City of Portland, Maine – Building or Use Permit Application 389 Congress Street, 04101, Tel: (207) 874-8703, FAX: 874-8716

Location of Construction: 88822 Codman Street 04103		Owner: Gregory DeWitt & Barbara DeWitt		Phone: 779-1066		Permit No: 990985	
Owner Address: 22 Codman St.		Lessee/Buyer's Name:		Phone:		BusinessName:	
Contractor Name: Joseph Gallant		Address: 72 Main St. Westbrook, ME		Phone: 554-0219		<div style="border: 2px solid black; padding: 5px; text-align: center;"> PERMIT ISSUED Permit Issued: <div style="border: 1px solid black; padding: 5px; display: inline-block;"> SEP 13 1999 </div> CITY OF PORTLAND </div>	
Past Use: 1-Family		Proposed Use: Same		COST OF WORK: \$ 3,000 FIRE DEPT. <input type="checkbox"/> Approved <input type="checkbox"/> Denied Signature: _____ PEDESTRIAN ACTIVITIES DISTRICT (P.A.D.) Action: Approved <input type="checkbox"/> Approved with Conditions: <input type="checkbox"/> Denied <input type="checkbox"/> Signature: _____ Date: _____			
Proposed Project Description: Rebuilding of front porch to existing foundation.				Zoning Approval:

DATE: 1 Sep 99 ADDRESS: 22 Codman St. CBL: 129-H-005
REASON FOR PERMIT: Re build Front Porch on existing Fou

Front Porch VIEW

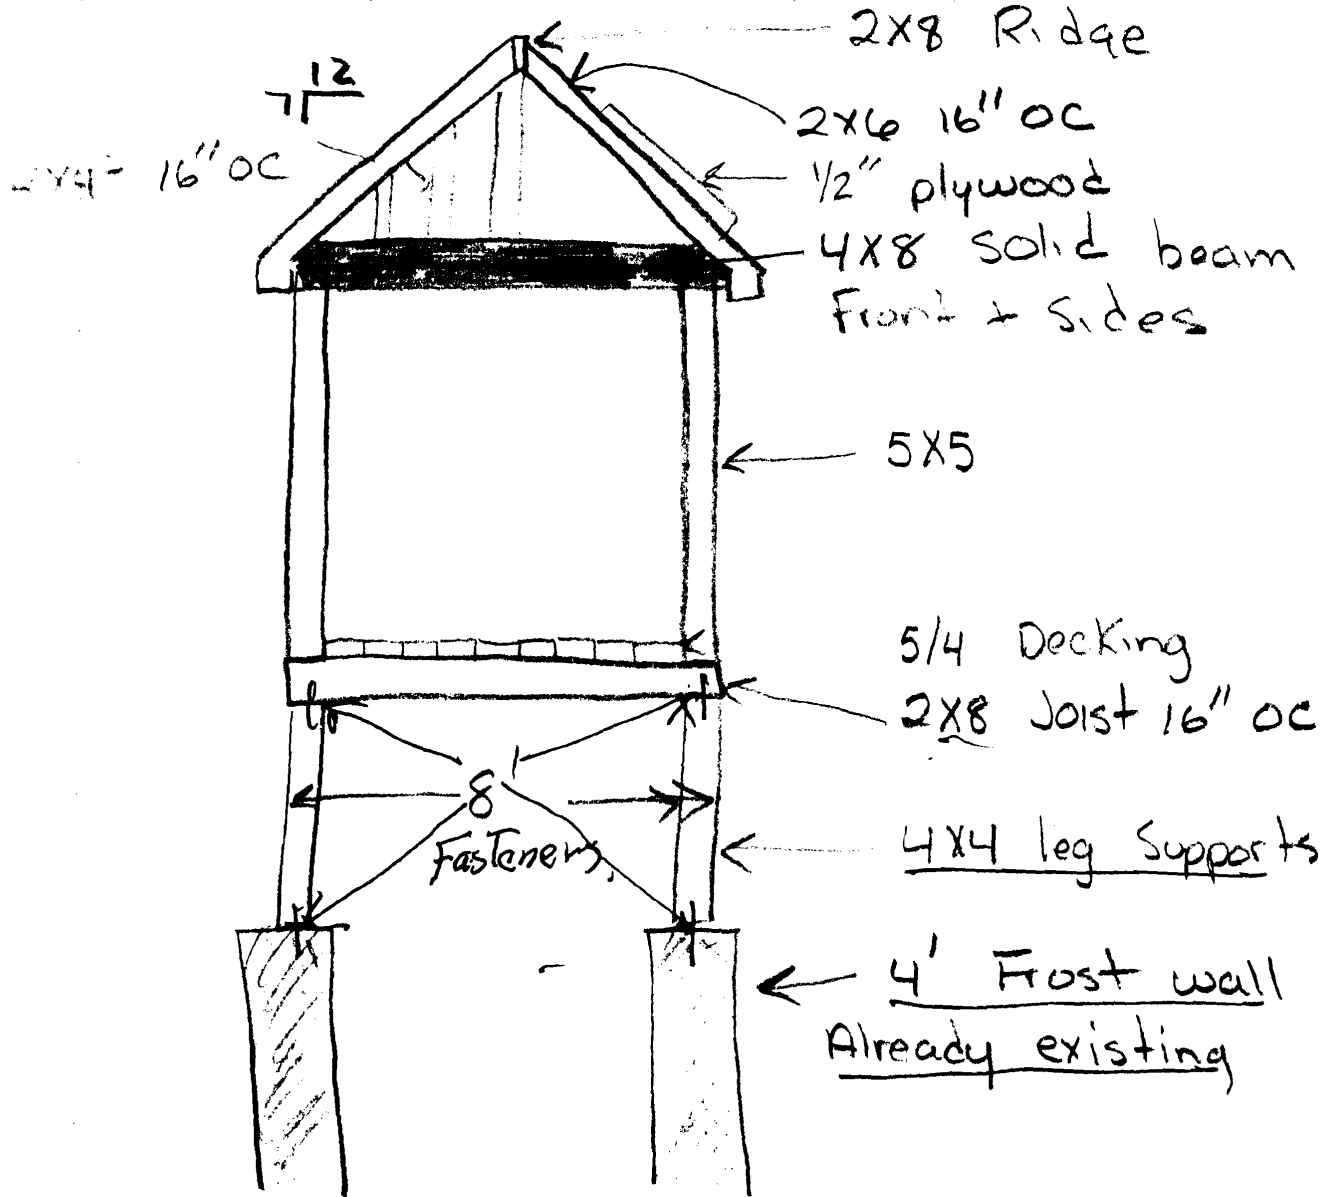
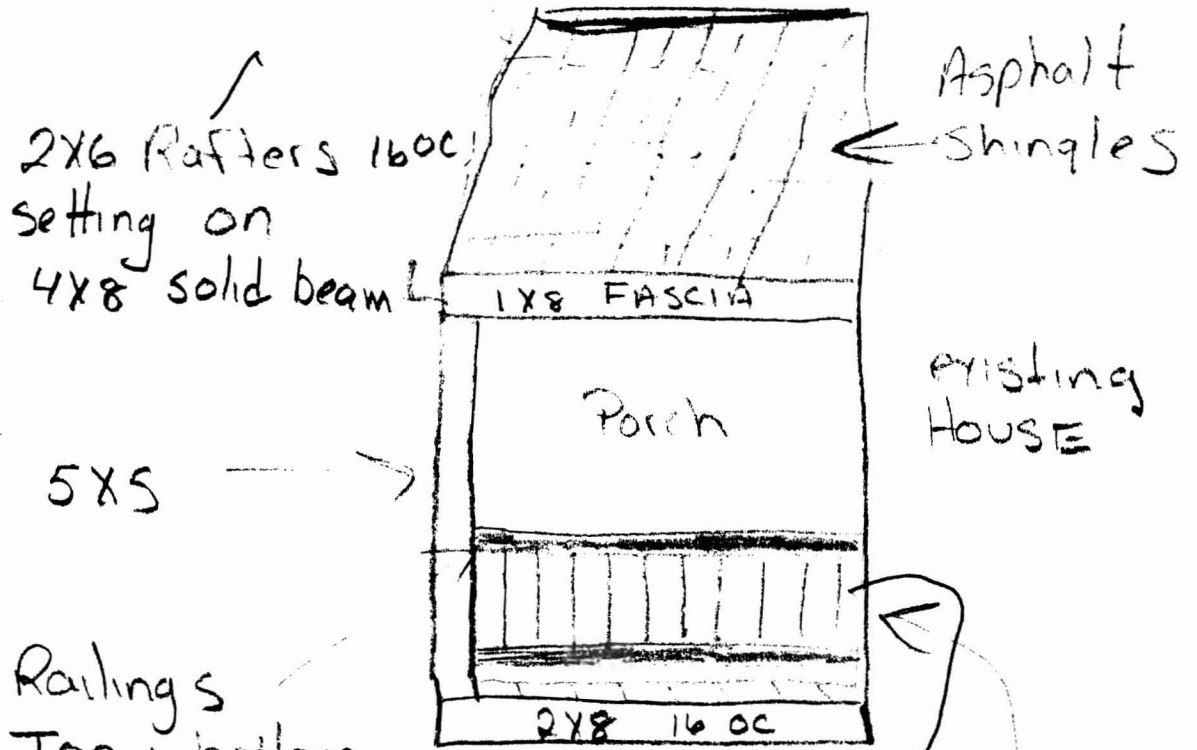
See Report T.

This permit is being issued with the understanding that the following conditions are met: *1, *11, *13, *29, *32, *33, *35
Approved with the following conditions: _____

- 10. Sound transmission control in residential building shall be done in accordance with Chapter 12, Section 1214.0 of the City's Building Code.
- X 11. Guardrails & Handrails: A guardrail system is a system of building components located near the open sides of elevated walking surfaces for the purpose of minimizing the possibility of an accidental fall from the walking surface to the lower level. Minimum height all Use Groups 42", except Use Group R which is 36". In occupancies in Use Group A, B, H-4, I-1, I-2, M and R and public garages and open parking structures, open guards shall have balusters or be of solid material such that a sphere with a diameter of 4" cannot pass through any opening. Guards shall not have an ornamental pattern that would provide a ladder effect. (Handrails shall be a minimum of 3e4" but not more than 38". Use Group R-3 shall not be less than 30", but not more than 38".) Handrail grip size shall have a circular cross section with an outside diameter of at least 1 1/4" and not greater than 2". (Sections 1021 & 1022.0) - Handrails shall be on both sides of stairway. (Section 1014.7)

- 12. Headroom in habitable space is a minimum of 7'6". (Section 1204.0)
- X 13. Stair construction in Use Group R-3 & R-4 is a minimum of 10" tread and 7 3/4" maximum rise. All other Use Group minimum 11" tread, 7" maximum rise. (Section 1014.0)
